Hi-Fi Products Service Bulletin

CSA-13

Model: TC-WR80ES/WR820A/WR87ES/WR775/
WR590/WR535/WR545/WR635S/
WR670/WR690/WR701ES/WR720A/
WR720/WR801ES/WR790 **No. 410**

Subject: New Spring for Replacement Head Base Assembly **Date:** September 7, 1994

HEAD BASE ASSEMBLY

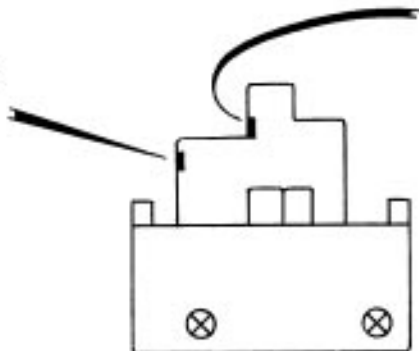
There are two types of head base assemblies and head base springs. Use the new type of head base spring (listed below) when the new type head base assembly is used

FOR THE FORMER TYPE
ONE END OF THE HEAD
BASE SPRING IS HOOKED
ON TO THE SHADED
PORTION AS SHOWN

FOR THE NEW TYPE,
ONE END OF THE HEAD
BASE SPRING IS HOOKED
ON TO THE SHADED
PORTION AS SHOWN

FORMER		NEW	
DESCRIPTION	PART NUMBER	DESCRIPTION	PART NUMBER
HEAD BASE SPRING	3-359-455-01	HEAD BASE SPRING	3-907-362-01
